Silicon Detector Challenges

For the Nab Detector Review

October 26, 2023

Summary: Issues to be Discussed

Wire Bond Breakages

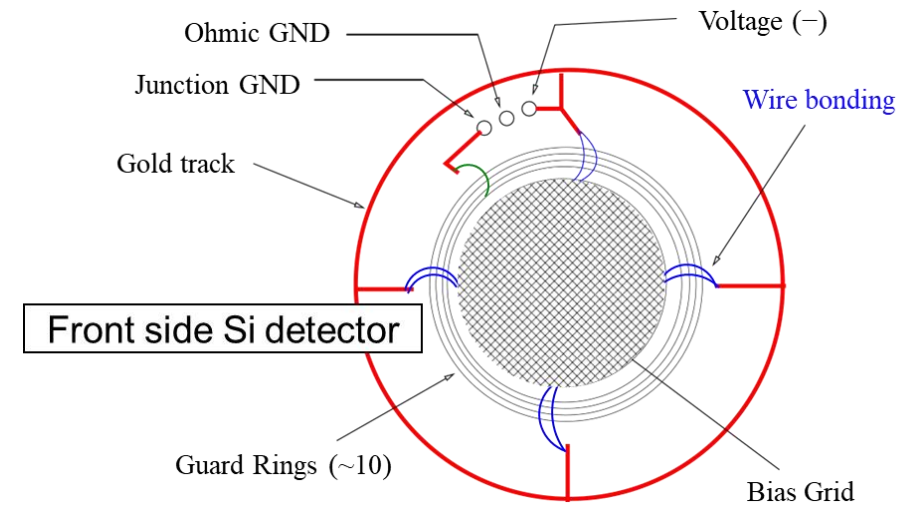
- Thermal cycles break the wirebonds
- Possible causes:
 - Uneven stress on detector ceramic causing flexing?
 - Wirebonds too tight?
- Assessment from T. McKnight (ORNL):
 - "There is insufficient LOOP of the wire from the bonding pad on the wafer to the exterior wirebonding posts"

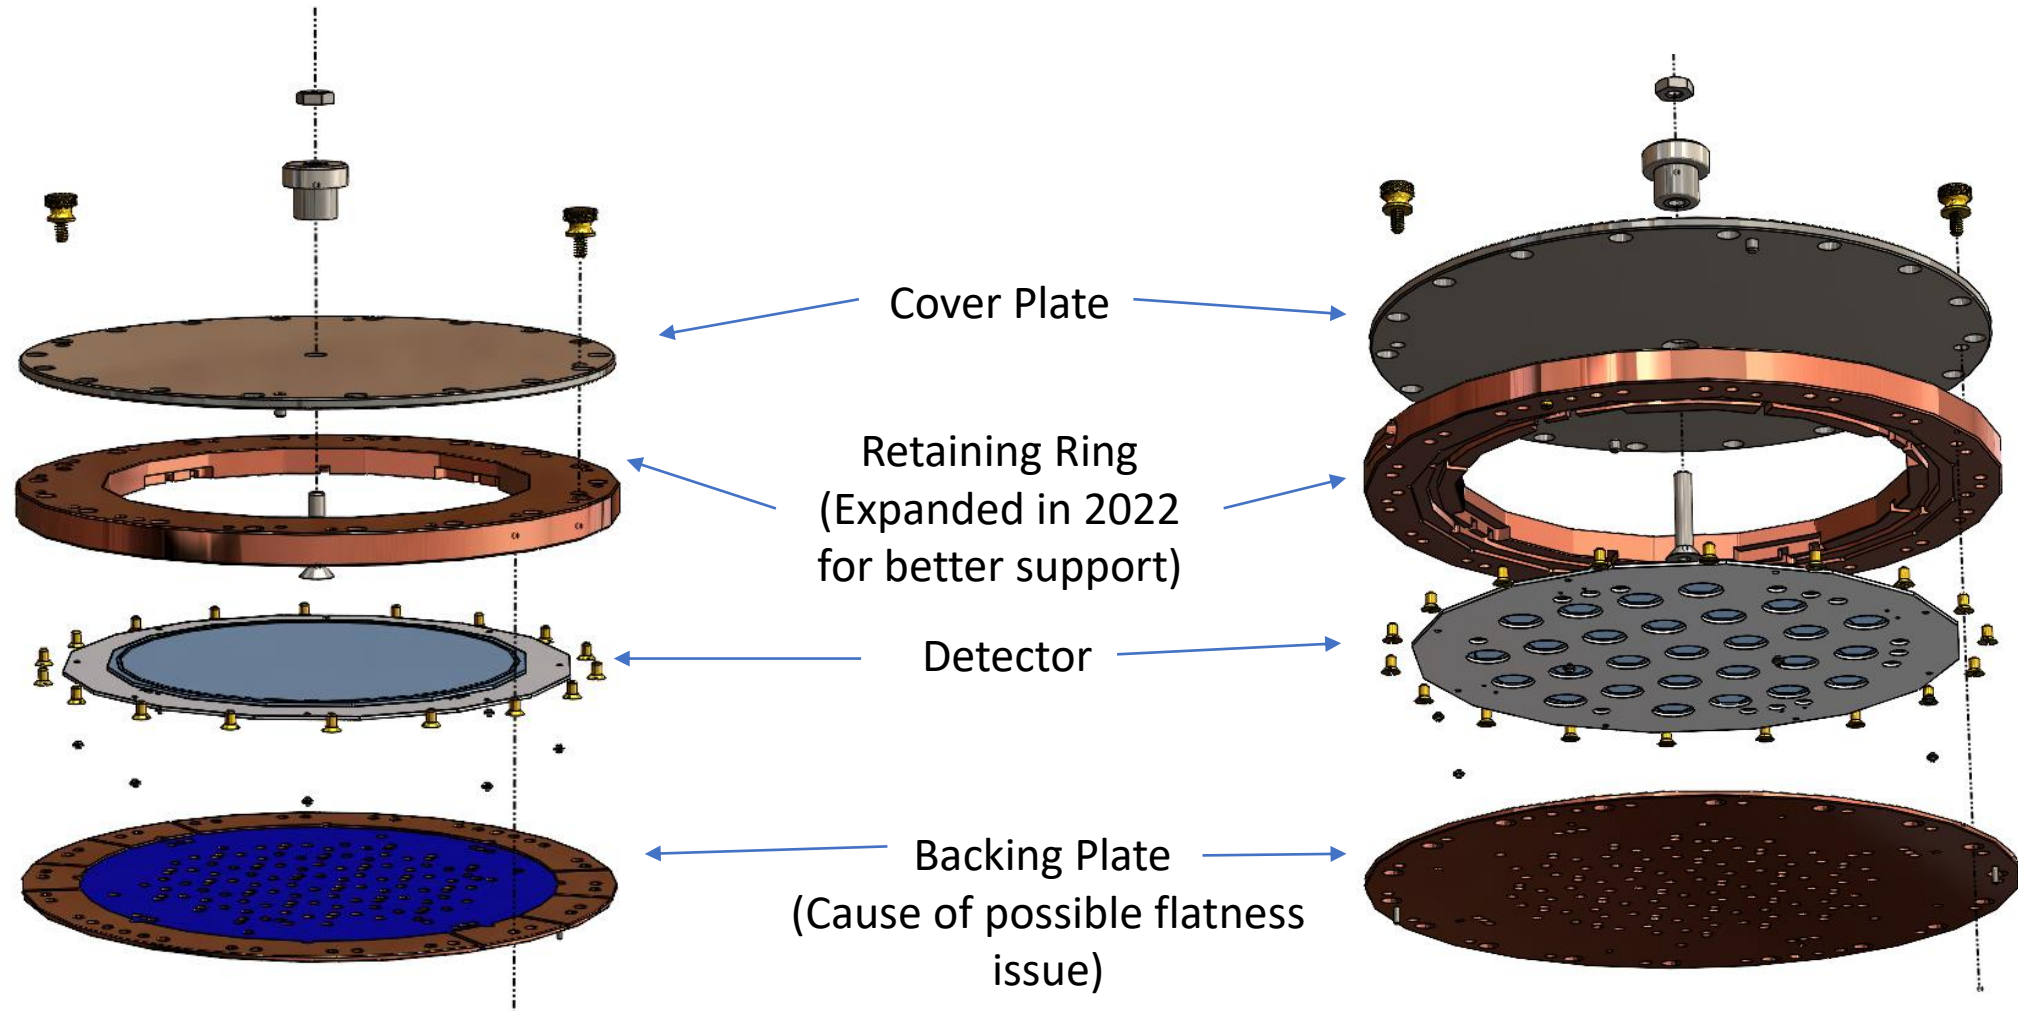
Intact Wirebond

Broken Wirebond

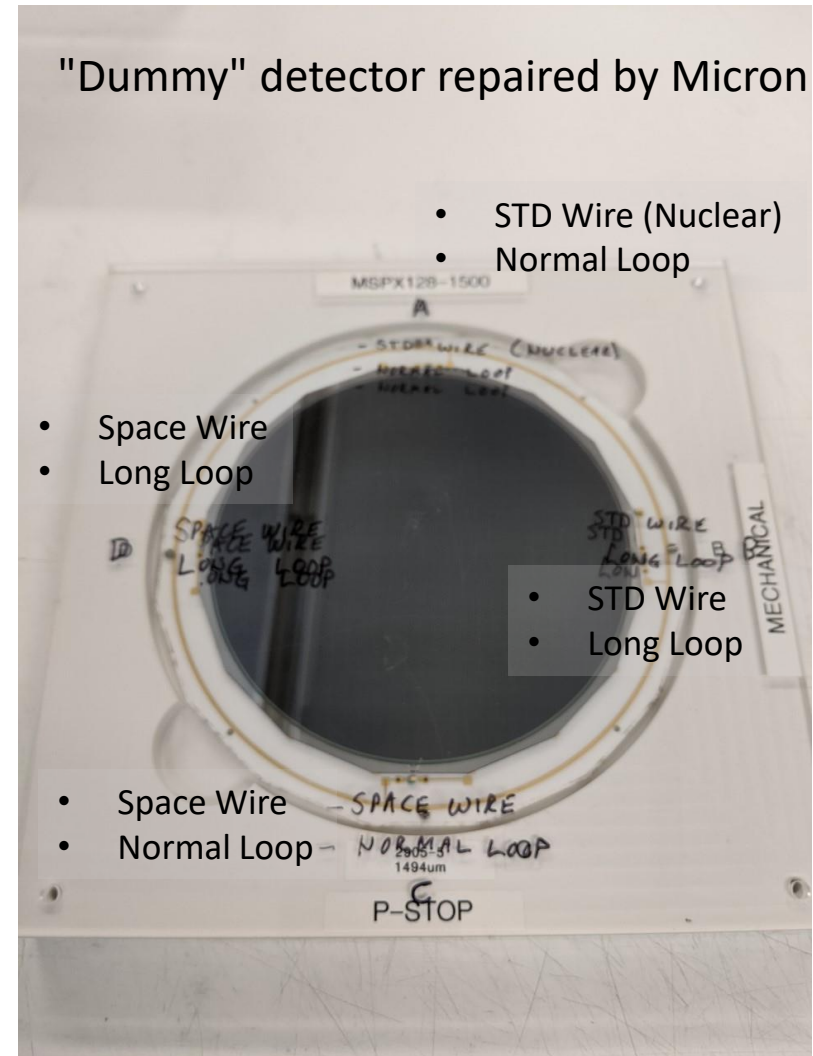
Re-machined Detector Armor

Re-done Wirebonds

- Repaired wirebonds with more slack
- Repairs done at both Micron and ORNL (Tim McKnight)
 - Micron repairs slow (~2 years, but during COVID-19)
 - Tim has retired
- Combination of repaired wirebonds and new armor has survived many thermal cycles
 - Only have 1 “good” detector with wirebond modification

Should we pre-emptively modify the wirebonds? How?

Major Issue 2: High leakage current on lower detector

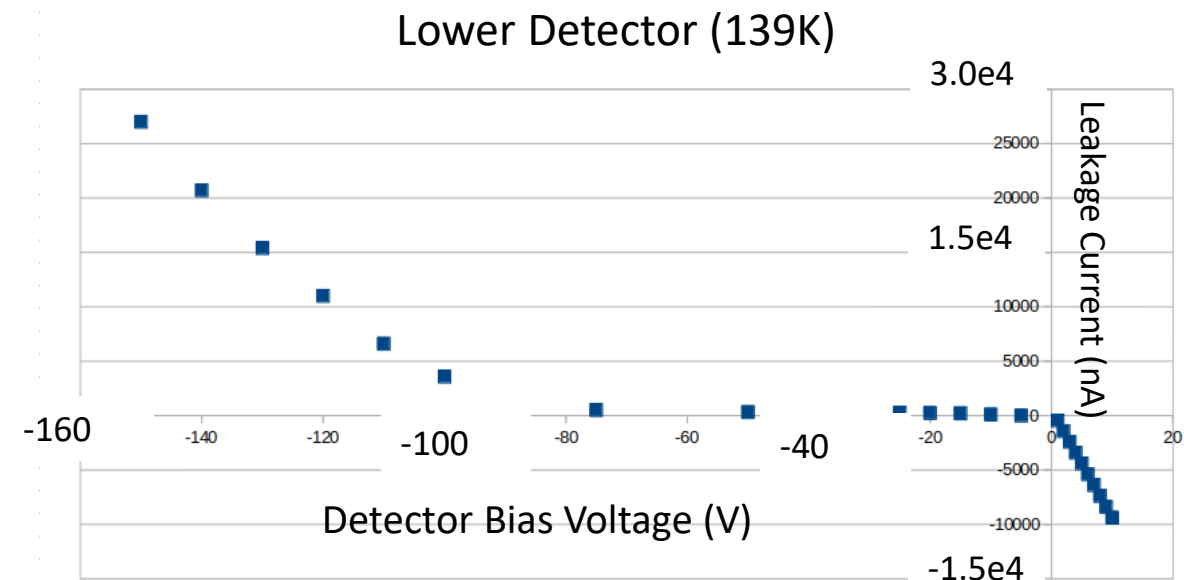
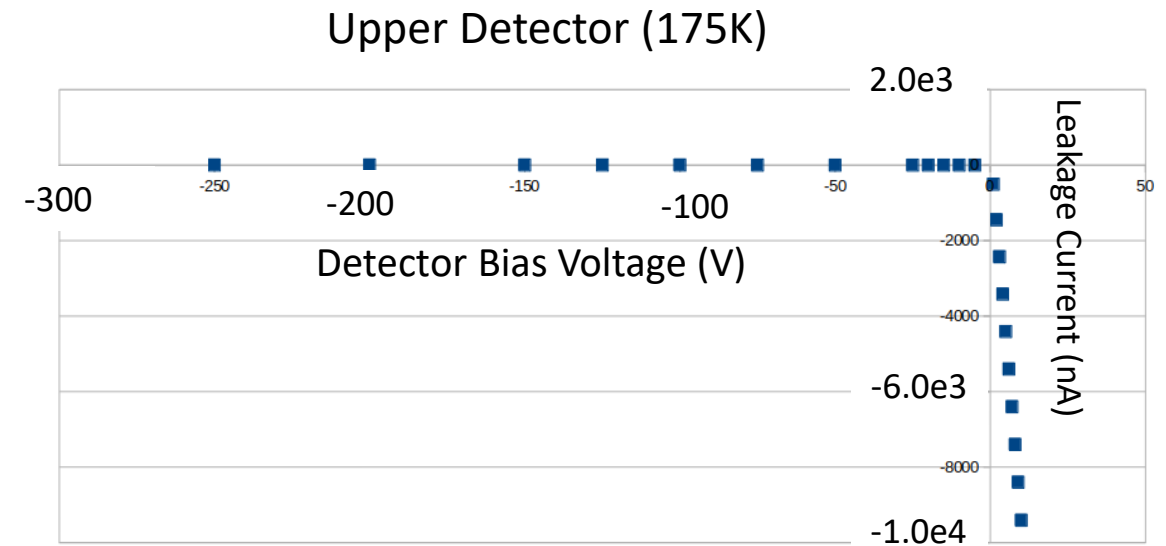
- Two detectors installed into spectrometer
 - Upper detector underwent extensive testing at Manitoba
 - Lower detector installed with wirebonds recently repaired by Micron
 - No low temperature or source tests on lower detector due to long turnaround
- After installation of lower detector:
 - Anomalously high leakage current
 - Negative pulses (assume from detector breakdowns – surface contamination?)
 - Prevents operation above -50V bias

Proton Peak Lower than Expected

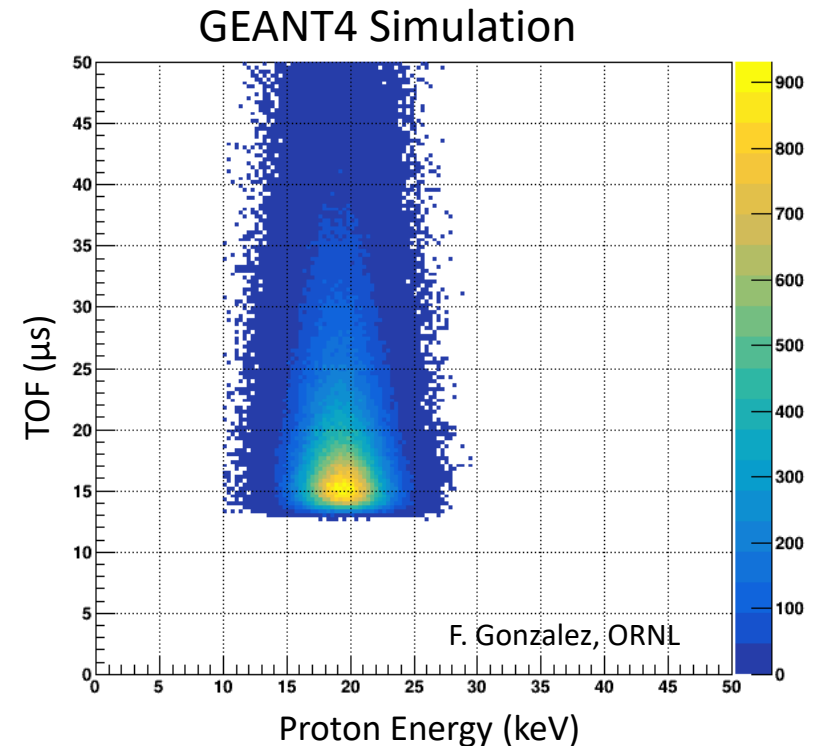
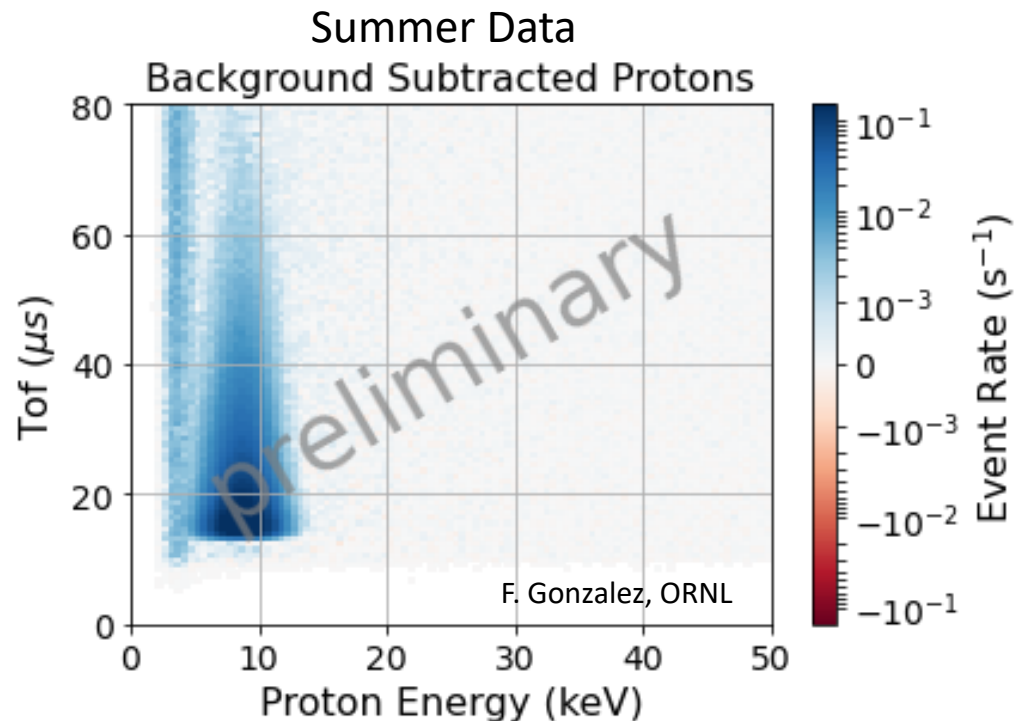
- Recall: Protons accelerated to detector by 30 kV accelerating potential
 - Expect to see proton peak from 30 keV protons at ~ 19 keV given 100 nm Si deadlayer (ideal case)
 - See peak ~ 2 x lower than expected (but still working on low energy calibration)

Communication from Tim McKnight

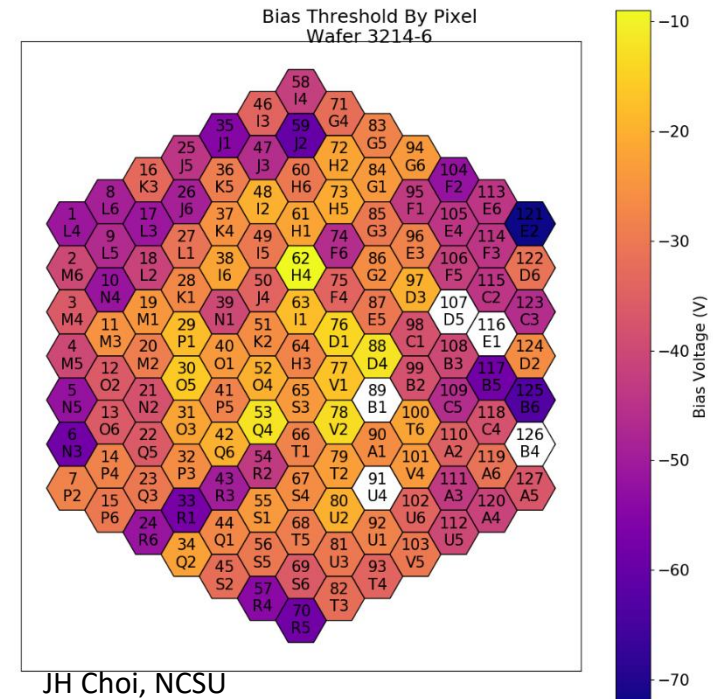
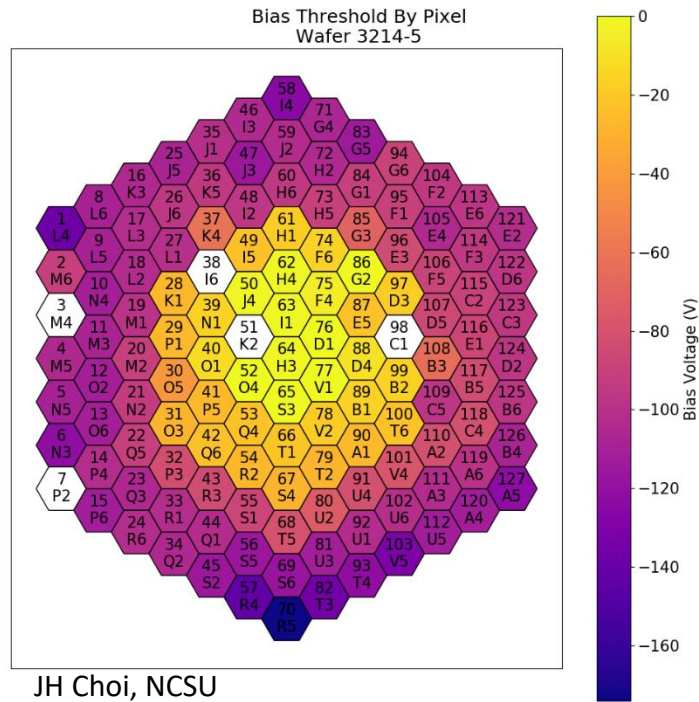
- There is insufficient LOOP of the wire from the bonding pad on the wafer to the exterior wirebonding posts. The wire therefore is tensioned across the edge of the wafer and this is imparting stress to the wire (particularly if there is any differential thermal expansion after the bond is made) and pulling the wire off typically at the pad on the wafer, but also sometimes on the exterior post. The bend in the wire caused by this can be seen at 3 of the 4 quadrants.

- Another issue I see is that there is some material on one of the four quadrant bonding pads. This appears to be a glue or adhesive (epoxy) perhaps used to help secure the bond. This will need to be removed from the pad prior to attempting to repair this bond. Any info on what this material is would be beneficial to aid in decisions regarding its removal.

- Solution is to provide more loop to the wire such that it does not interact with the edge of the wafer. If the wirebonder LOOP settings do not provide sufficient loop, then a manual process can be used whereby you drag the bonder beyond the target pad and then move back to the target pad prior to making the second bond. This will feed additional wire to provide sufficient loop.

- I have been able to successfully repair I believe all 4 quadrant connections on your detector, in addition to the 'grounding' ring at the periphery. 3 of the 4 quadrants and the ground ring have two bonds for a bit of redundancy, but the remaining quadrant has only 1. This latter was the one covered in 'goop'. Upon trying to make a bond, the goop appeared to be still liquid and I believe the Wedge bonder pressed through it to make the connection. This connection may be more resistive than others if there is an interfacial layer of goop. I tried to make two bonds on this electrode, but subsequent bonds were unsuccessful. All bonds have sufficient loop so as to not be in contact with the edge of the detector. Hopefully this will resolve any thermal/mechanical problems associated with the wire being stressed over the edge as the previous bonds were.

Fast Detector Warmup at ORNL

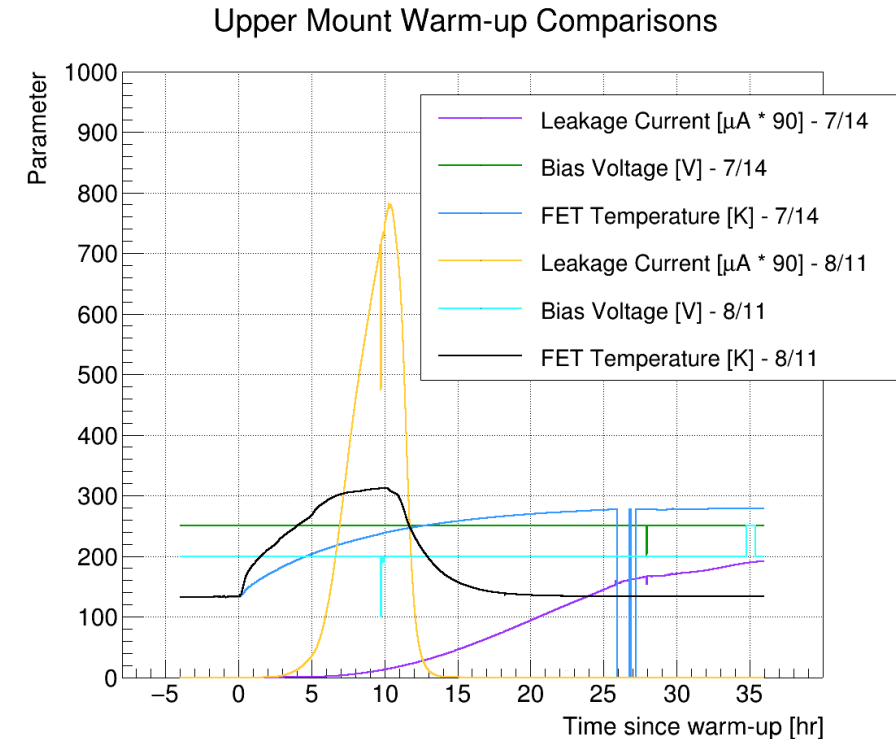
- Before summer data-taking, at FET temp 288K and -200V , $I_L = 3.3 \mu\text{A}$
- After too-low proton energy observed, attempted warmup of detector to remove ice
 - Note: no working detector temperature sensor, FETs previously within 10K of detector, but detector has much slower time constant (several hours slower to stabilize)
 - Used detector leakage current. Warmed up to $I_L = 8.6 \mu\text{A}$ (at 200V).
 - Aborted warmup due to concerns about magnet temperature (quench risk)
- No change in detected proton energy after warmup

How reliable / repeatable is leakage current as proxy for detector temperature?
